A G E N D A

Architectural Review Board

October 27, 2020 – 5:30 p.m.

1303 Felder Avenue

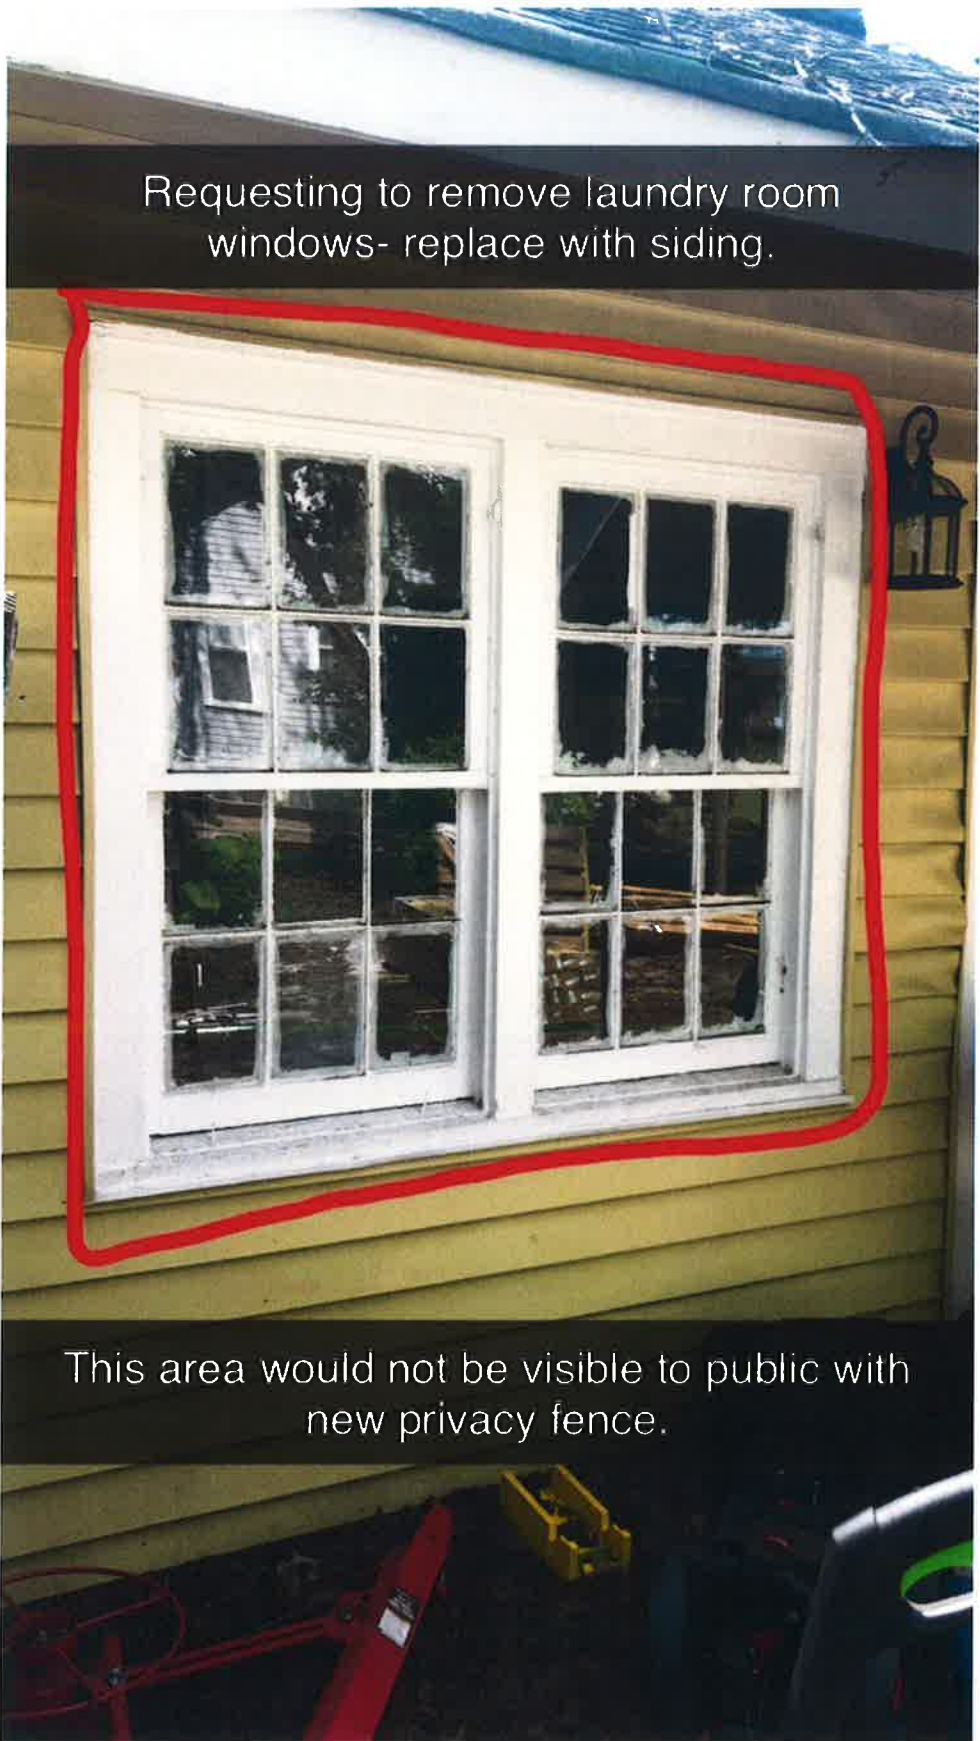
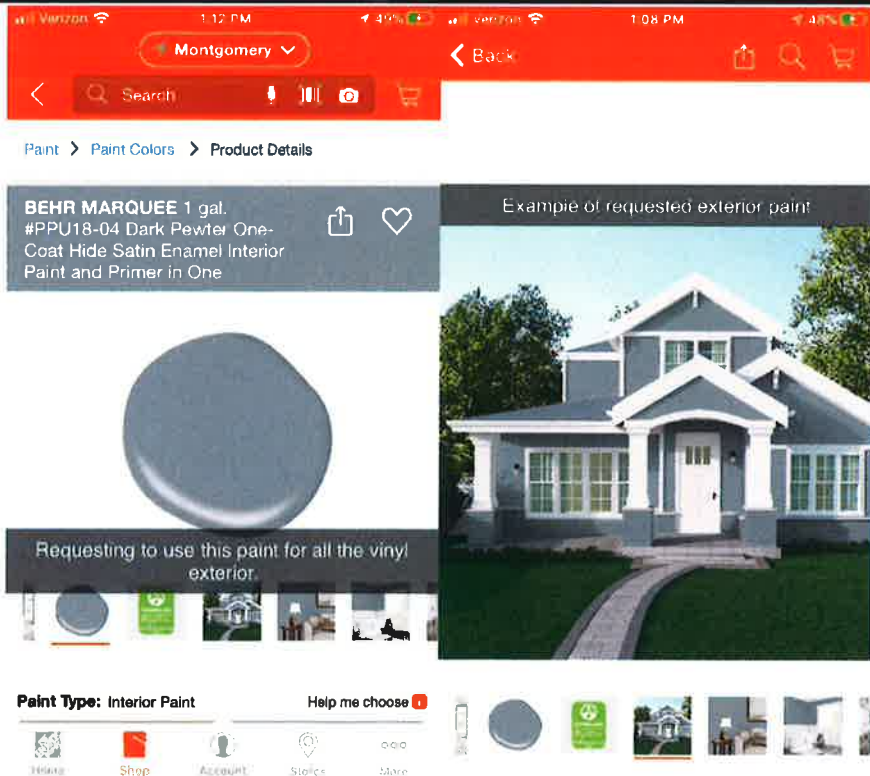
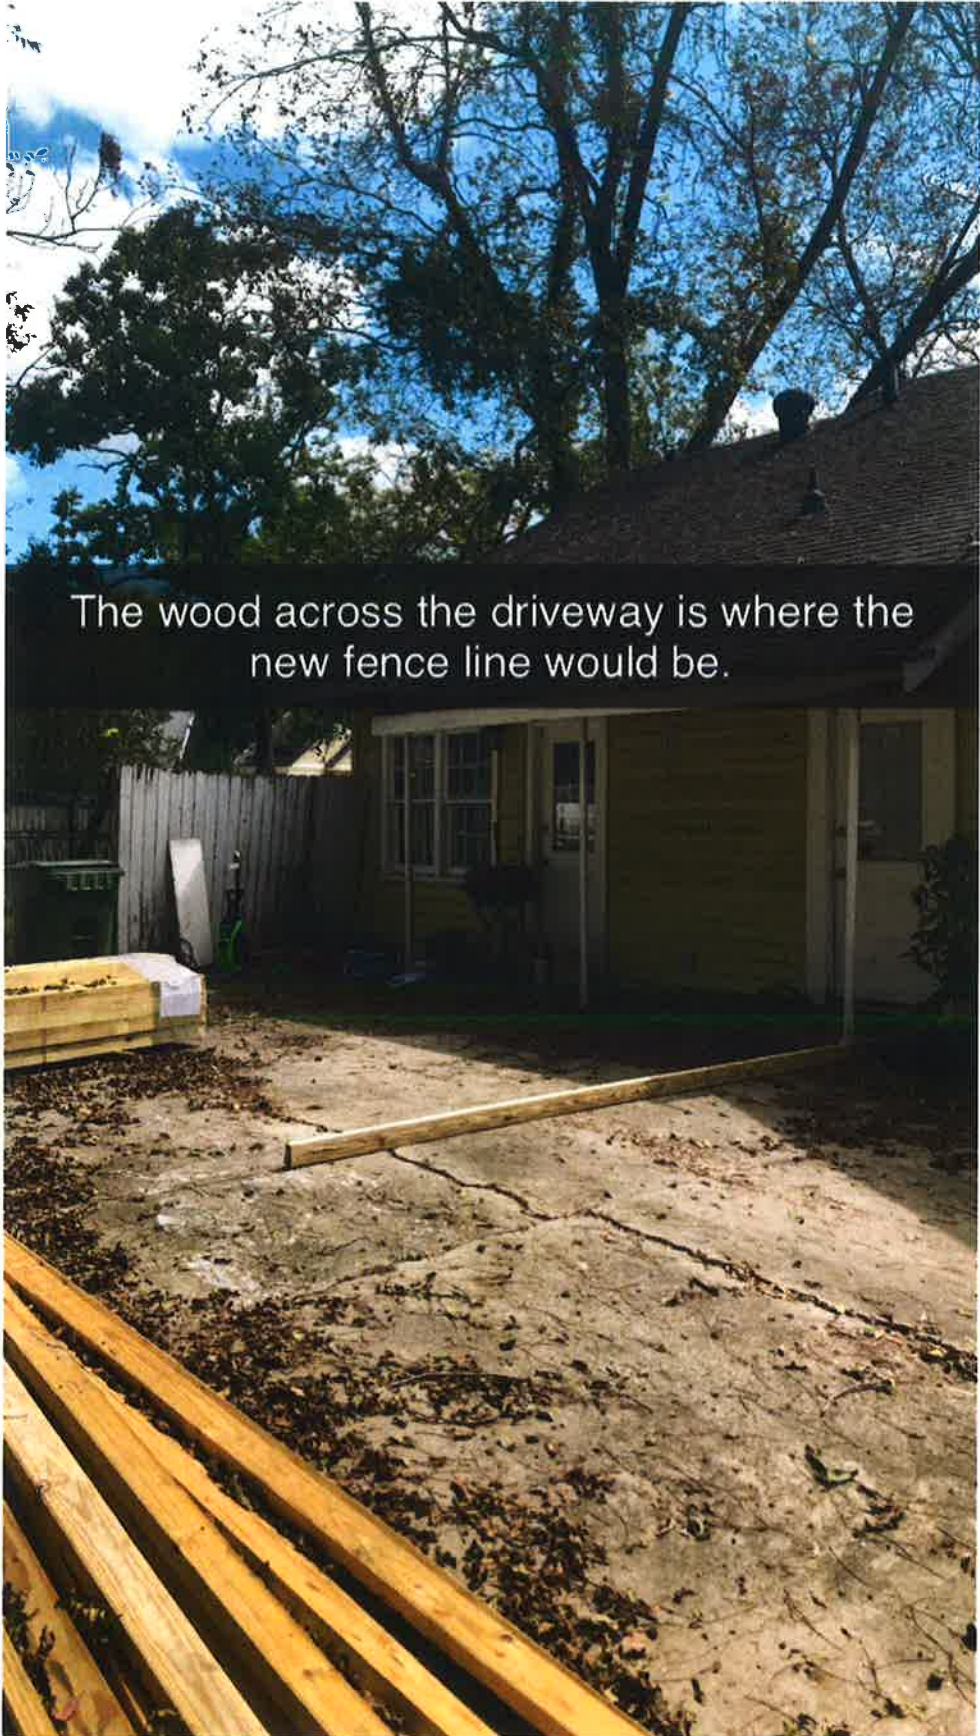
- The Board’s decisions on leaded glass in doors, which is not common as a historic feature, have been split. One door was approved with a preference for an alternate where two doors were proposed, but the owner opted for the Board’s second choice (Capitol Parkway); and one owner asking for permission after the fact (Cloverdale) was required to install a clear glass panel in place of the leaded glass.
- With the relocation of the fence on the north side, the removal of the door and windows will not be highly visible from the street, but will alter the fenestration on that side of the house considerably. It does appear this portion of the house may have been a later addition.
